**KAWARTHA PINE RIDGE DISTRICT SCHOOL BOARD
PUR24-072-ITT
Hampton Junior Public school Classroom Refresh**

ADDENDUM NO. 2

Project No.: 24004
Date: April 24, 2024
Tender No.: PUR24-072-ITT
Project: **KAWARTHA PINE RIDGE DISTRICT SCHOOL BOARD
Classroom Refresh at Hampton Jr. Public School**

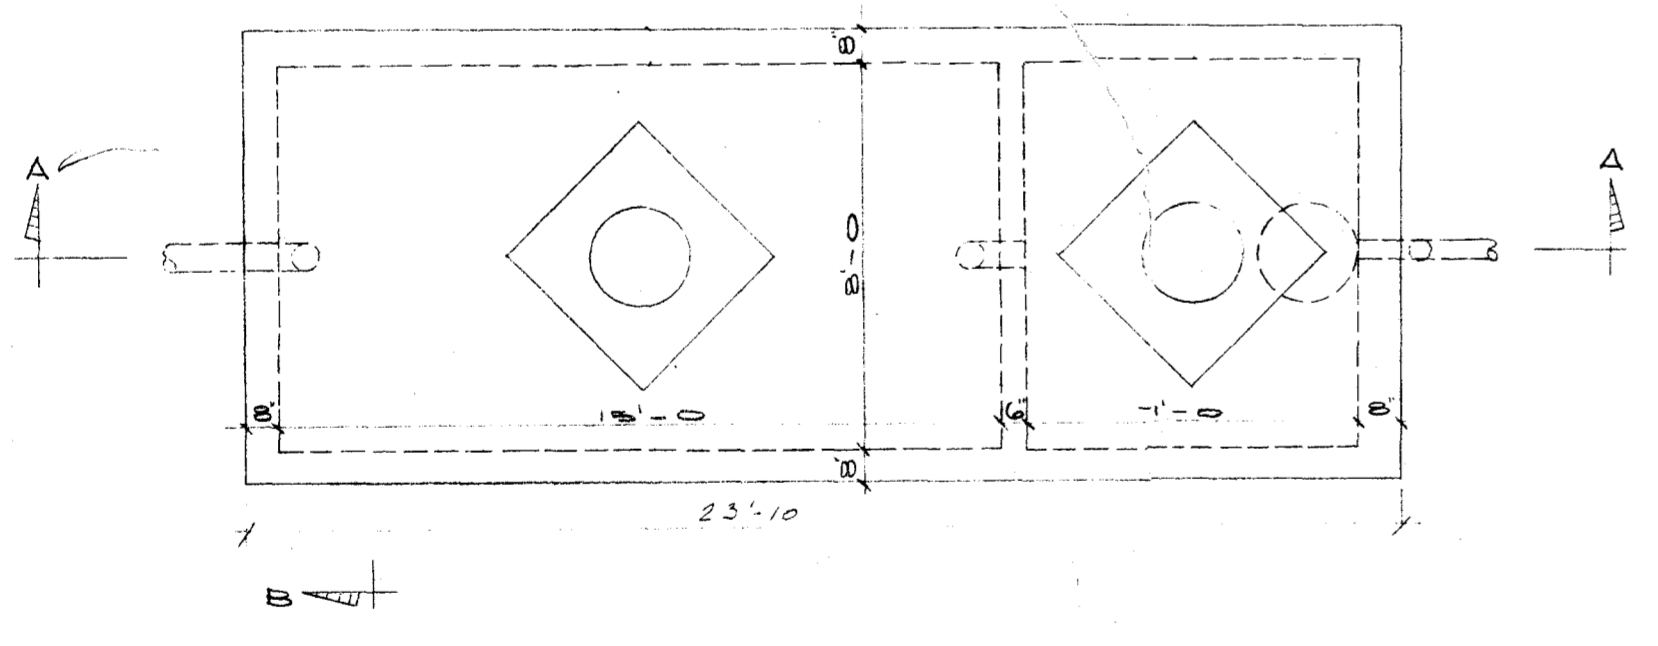
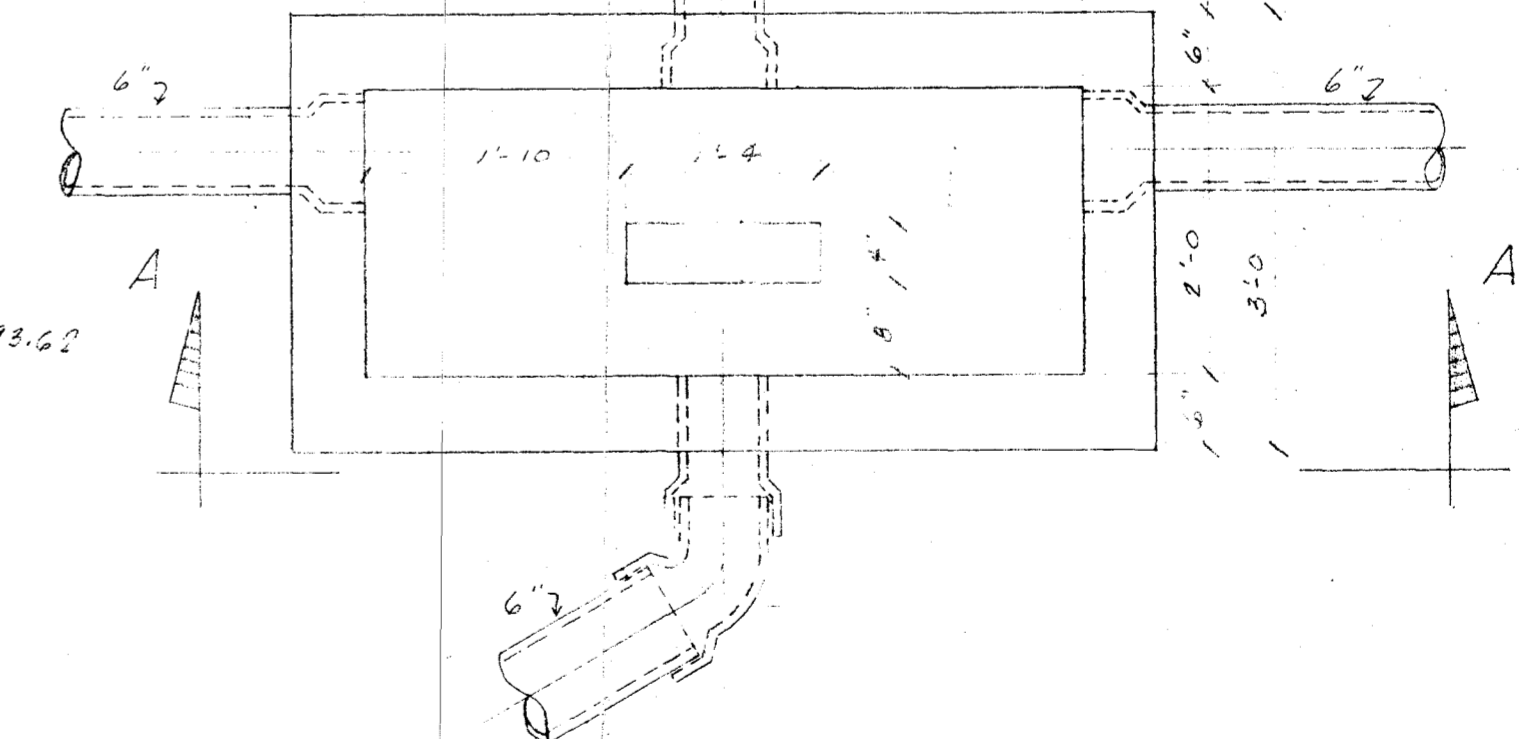
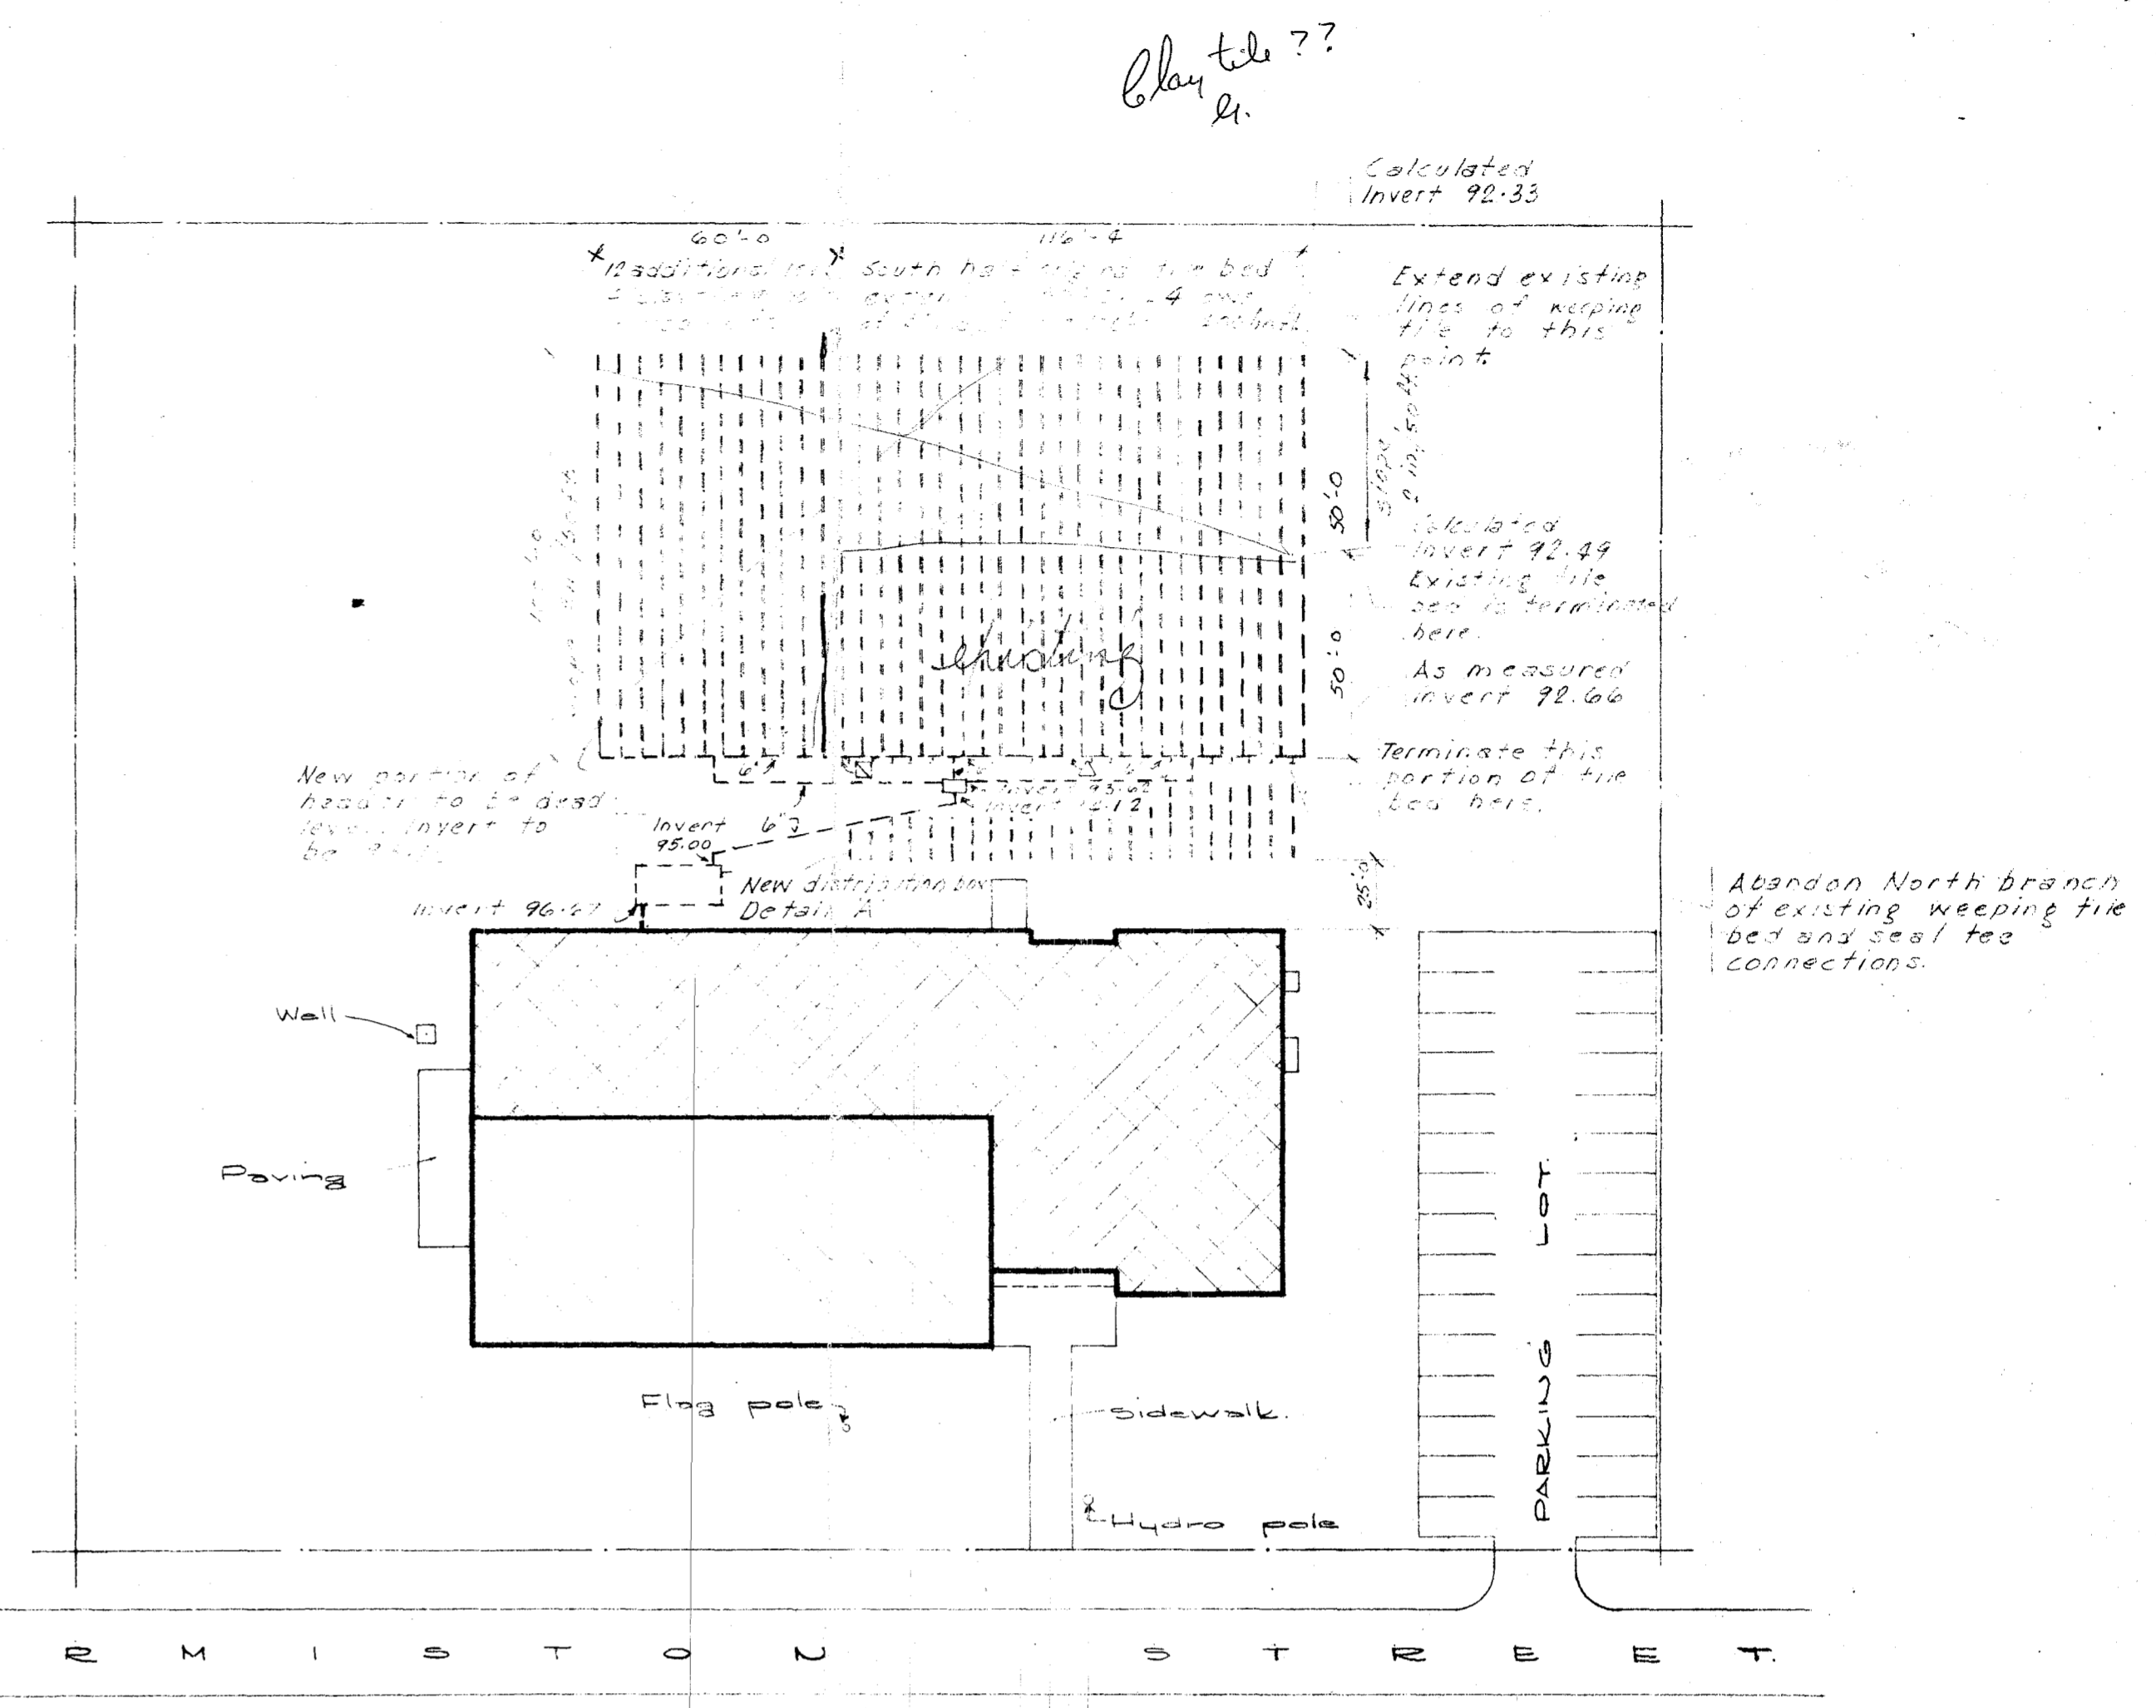
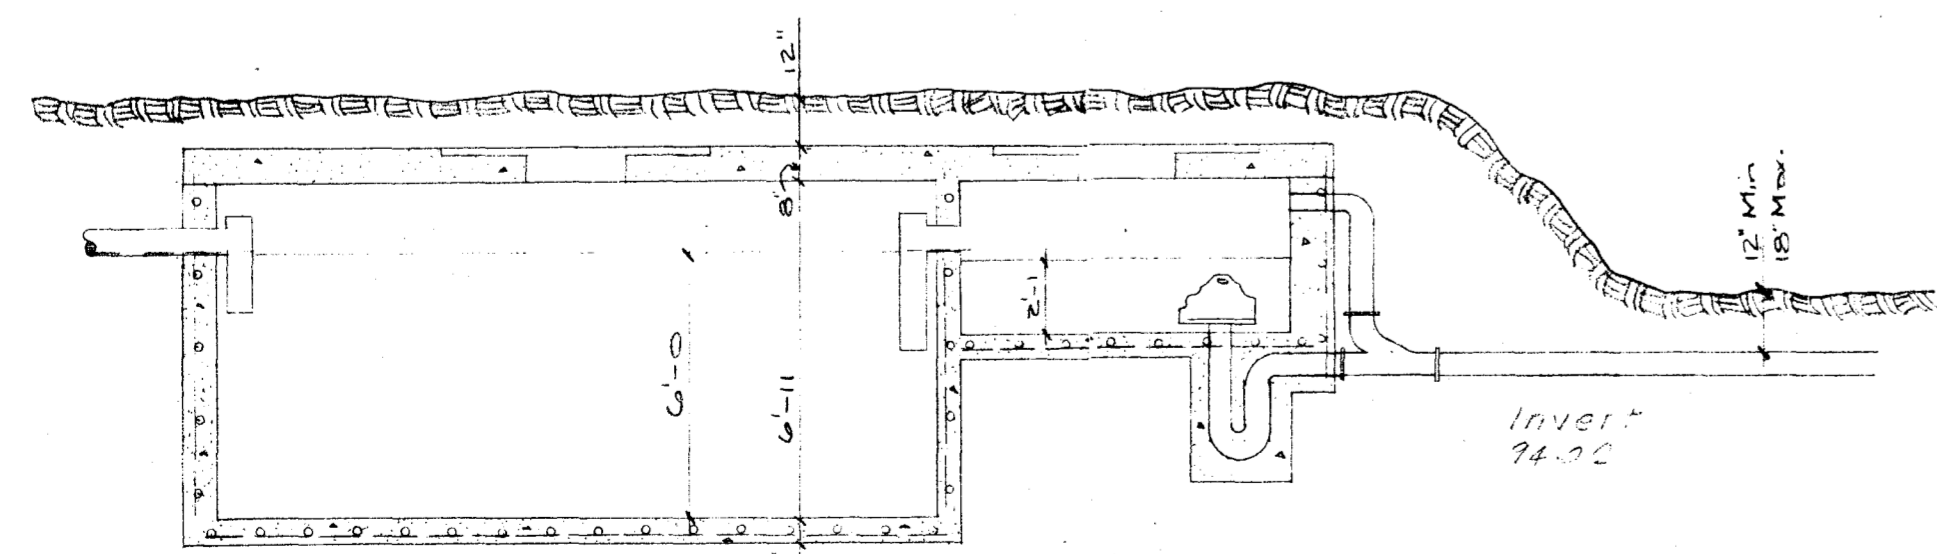
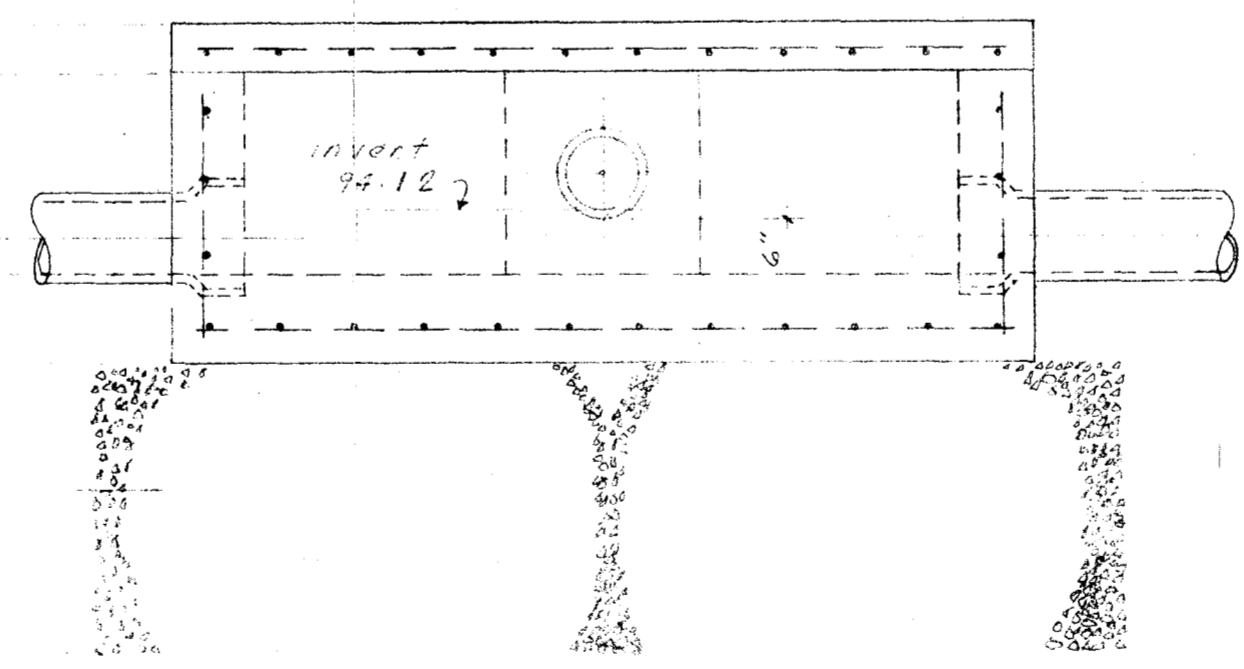
1.9 **Question:** Provide approximate invert depth of the existing sanitary pipe at connection points.

Answer: Please refer to the attached existing reference material DS-1 Existing and Proposed New Field Tile Disposal System.
